APPLICATION NO.	FILING DATE	FIRST NAMED INVENTOR	ATTORNEY DOCKET NO.	CONFIRMATION NO.
09/871,199	05/31/2001	James M. Kain	20341-67618	9889

**Advisory Action  
Before the Filing of an Appeal Brief**

KAIN, JAMES M.

Diagram A - Annotated Figure 1 of Mitchell

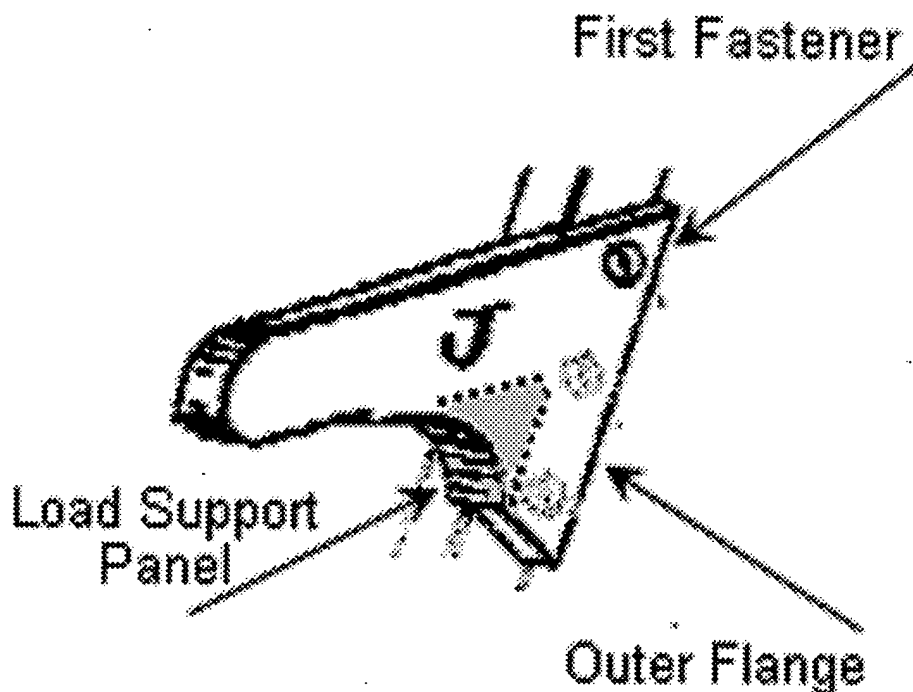
With respect to the armrest of Mitchell, Applicant appears to not understand the teachings of Mitchell. The armrest of Mitchell has a first fastener (see Diagram A below) and a load support panel that engages a ridge of the seat back to block pivotable movement of the armrest downward about a pivot axis established by the first fastener. See the previous Office Action for motivation to further modify the seat assembly of Lemmeyer et al. Diagram A sets forth the relationship of the load support panel and the flanged wings of the armrest such that the combination regarding claims 13 and 25 is apparent.
